Docket No. 50-336
A08915

Re: Inservice Test Program
10 CFR 50.55a(g)

Millstone Nuclear Power Station, Unit No. 2
Second Ten-Year Inservice Inspection Testing Program
Response to NRC Staff Request (TAC 75977)

Response to "IST Program Anomalies
Identified During the Review"

FIGURE 1

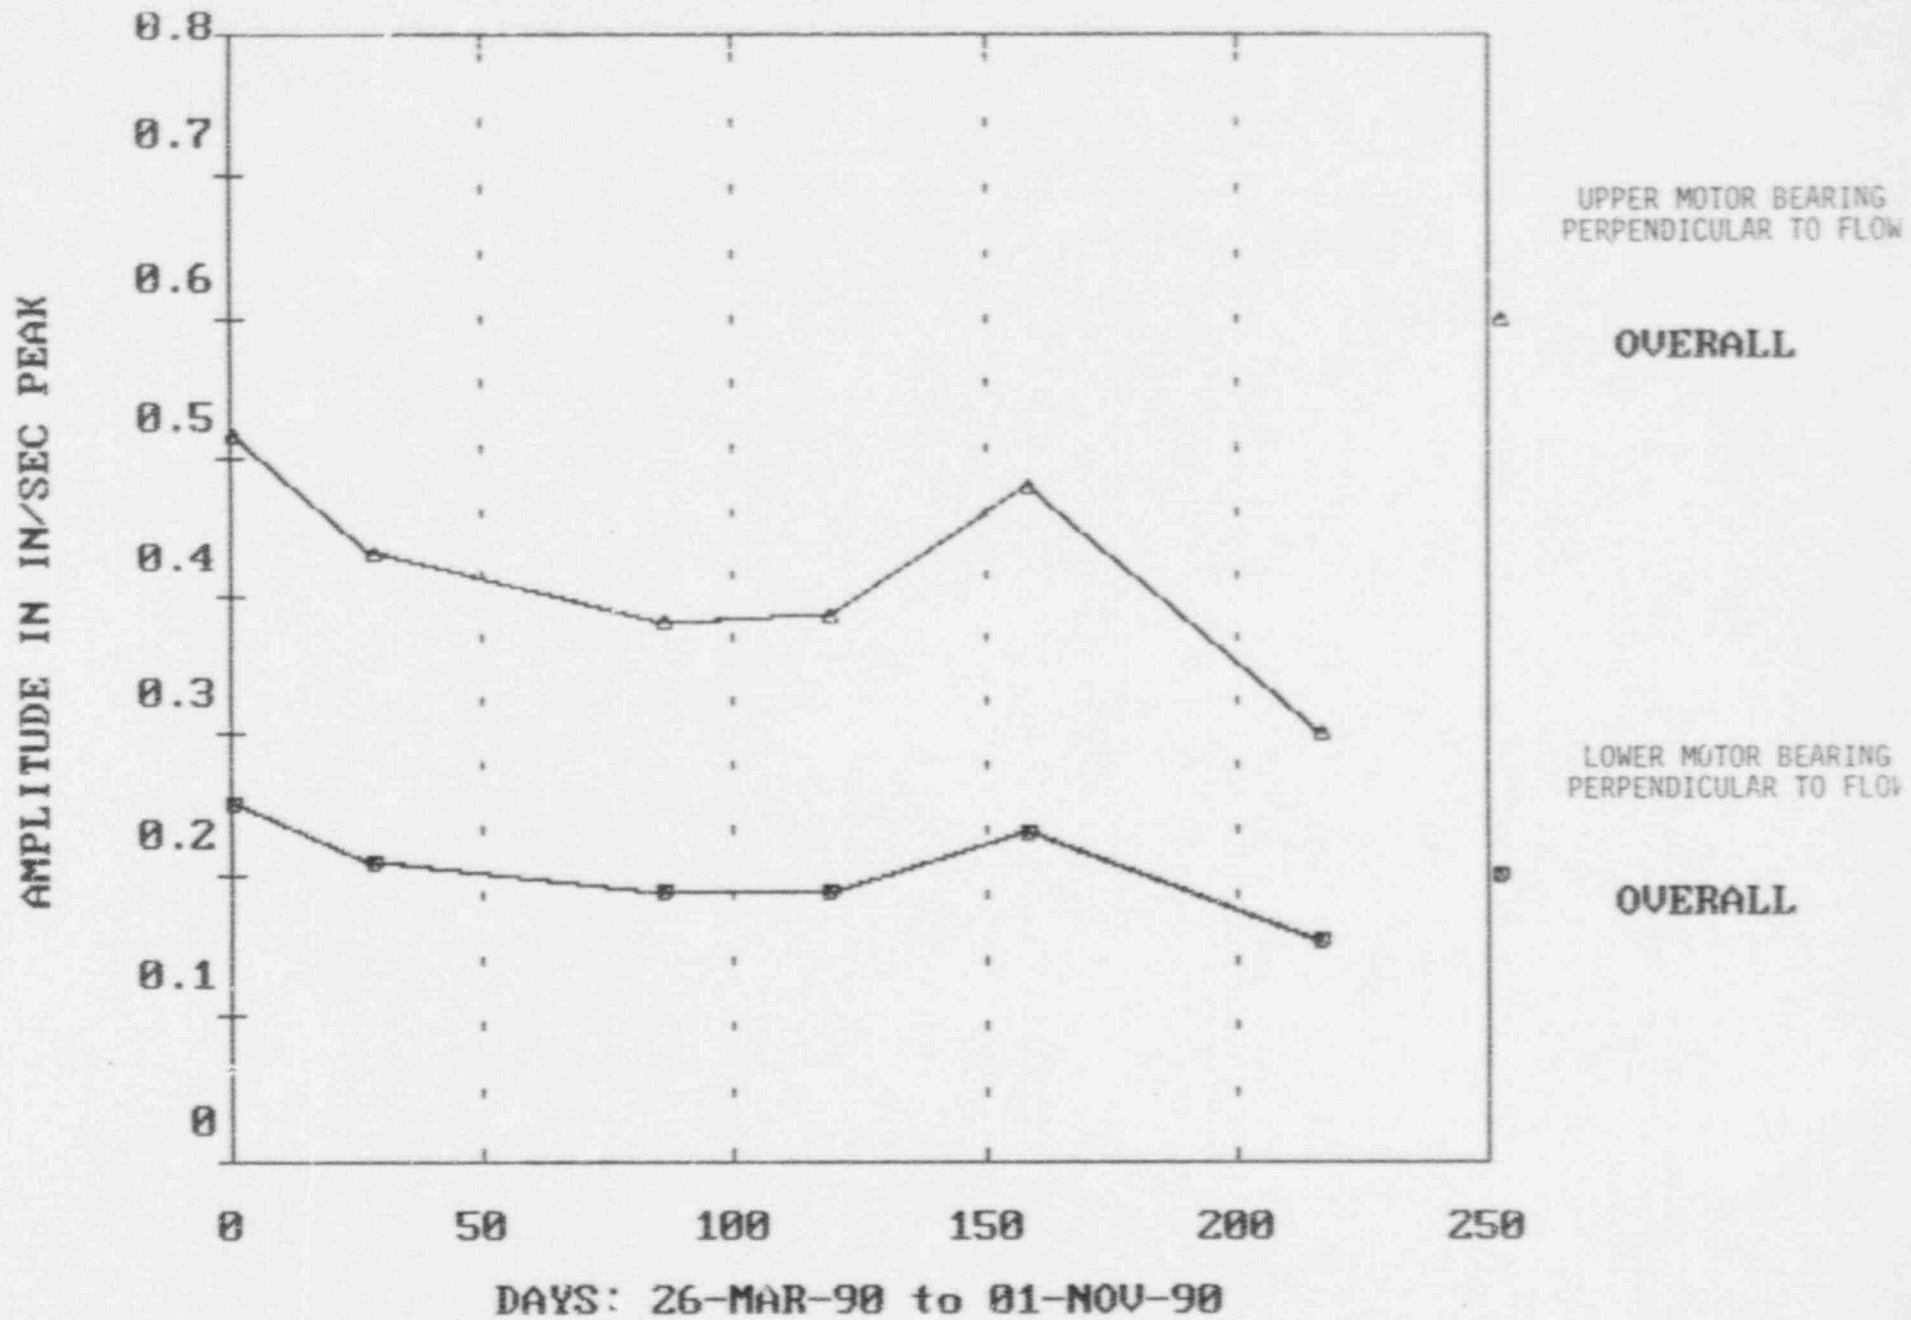
The above information demonstrates that the concern stated in the technical review, ". . . the assignment of 1.4 inches/second as the required action maximum limit does not seem reasonable since the pump is likely to fail prior to reaching this limit" is unfounded for these specific pumps. However, further review of historical data for these pumps indicates that assignment of a Required Action level of 1.0 inches/second would not be excessively burdensome. Therefore, relief request IWP-1 and the Millstone Unit No. 2 IST program have been revised to specify a Required Action level of 1.0 inches/second for the Service Water Pumps.

Experience and testing has shown that vibration at the upper motor bearing housing is two to three times higher than measurements taken closer to the pump. Figure 1 demonstrates the differences in upper and lower motor bearing housing vibration levels. Recent testing performed with temporary accelerometers installed on the pump column, showed that when the upper motor housing vibration level was 0.42 inches per second, the actual pump vibration level was 0.16 inches per second.

This additional information and the proposed reduction in the Required Action level to 1.0 inches/second addresses the technical concerns expressed in the TER section 3.2.i. Permanent relief request for IWP-1 is hereby requested from NRC Staff.
